NOTICE TO CONTRACTORS BIDDING THIS PROJECT

Project Title: Building and Site Improvements at 6741 Downing Avenue, Bakersfield, CA

Contract No: 26016

ADDENDUM No. 9

JOB	
DP	
PM	
	S2.1A

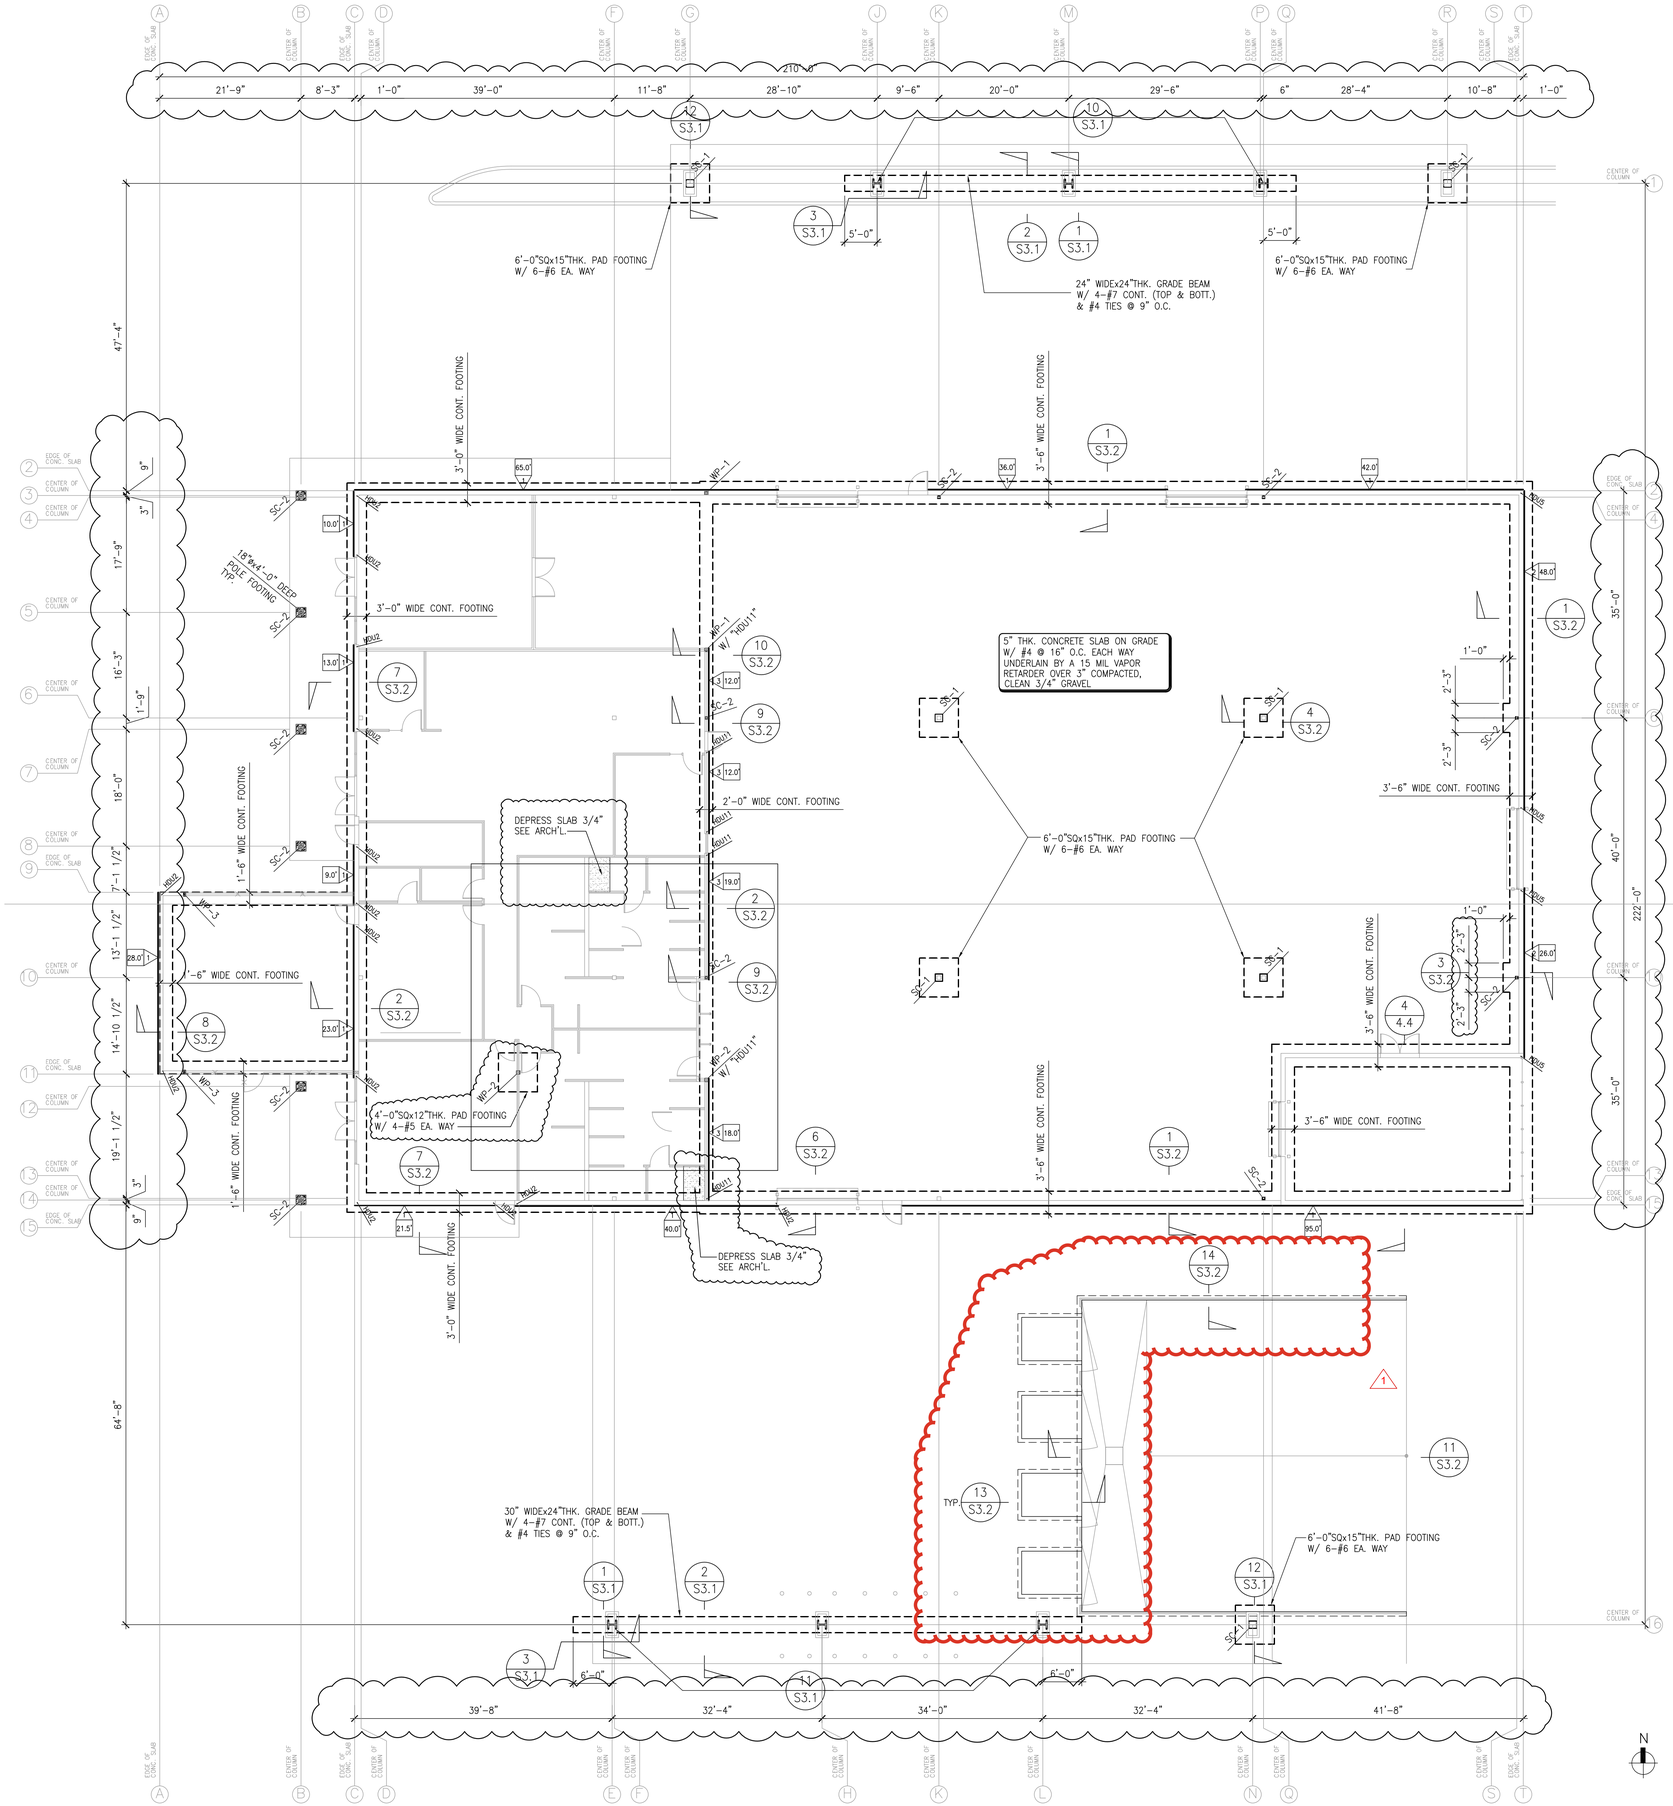
g. Sheet S2.1 has been replaced with sheet S2.1A. The foundation plan has been revised to include information for the dock leveler pit. The revised sheet is attached to this addendum.

DOCK LEVELER SECTION

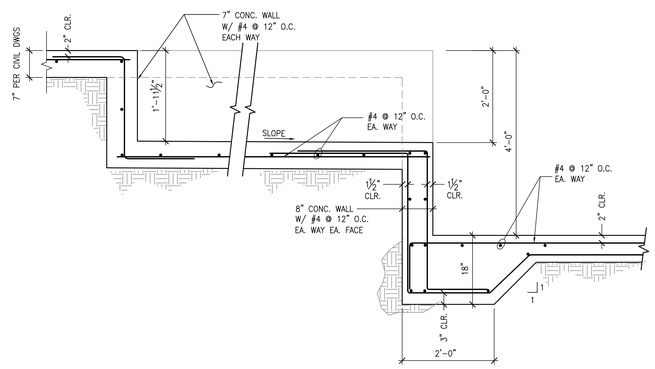
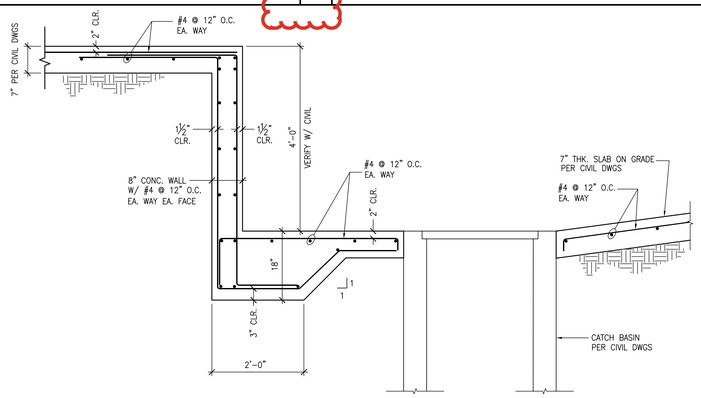
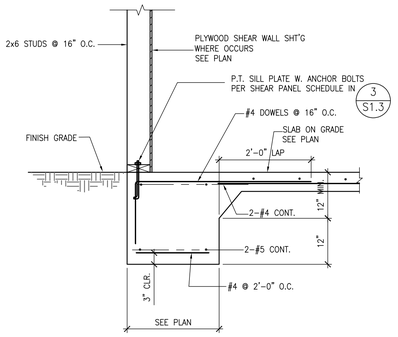
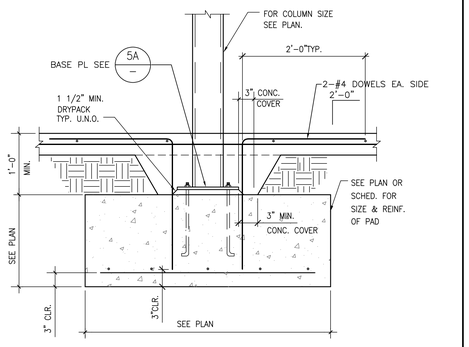
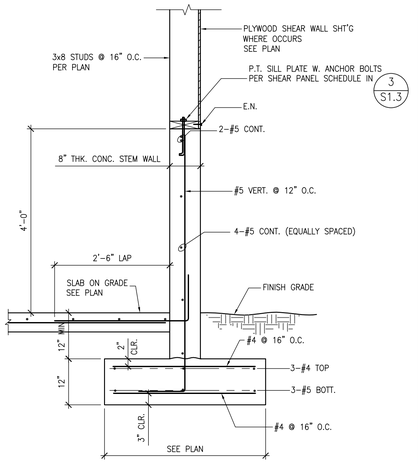
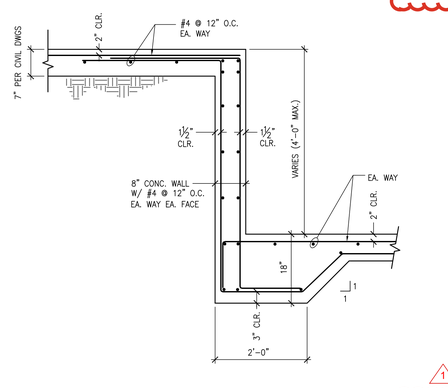
h. Sheet S3.2 has been replaced with sheet S3.2A. Additional details have been provided for the dock leveler pit. The revised sheet is attached to this addendum.

ENLARGED POWER FLOOR PLAN - NORTH

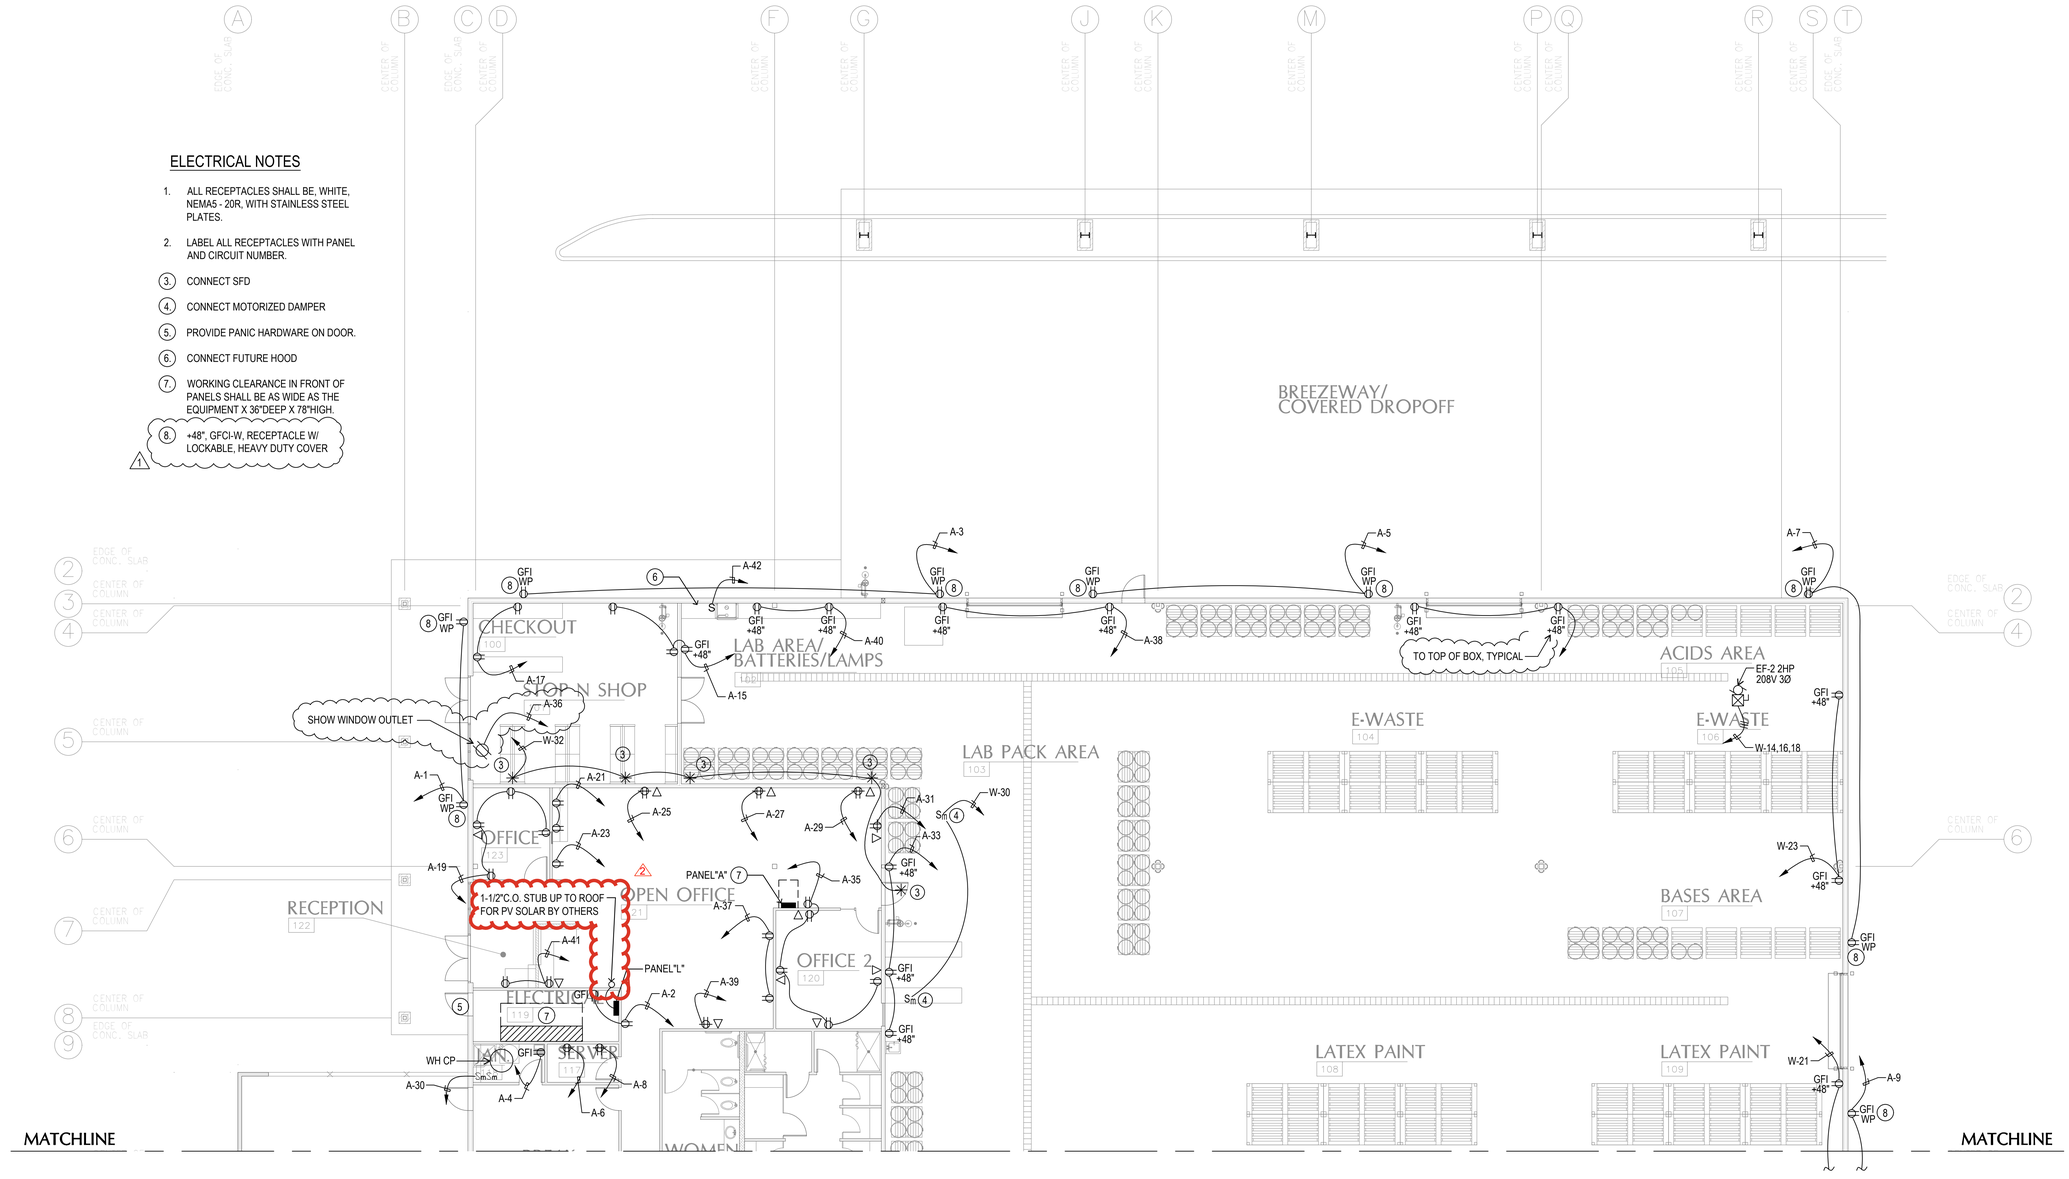
i. Sheet E211A has been replaced with sheet E211B. Conduit stub out has been added to Panel "L" for connection to PV system. The revised sheet is attached to this addendum.
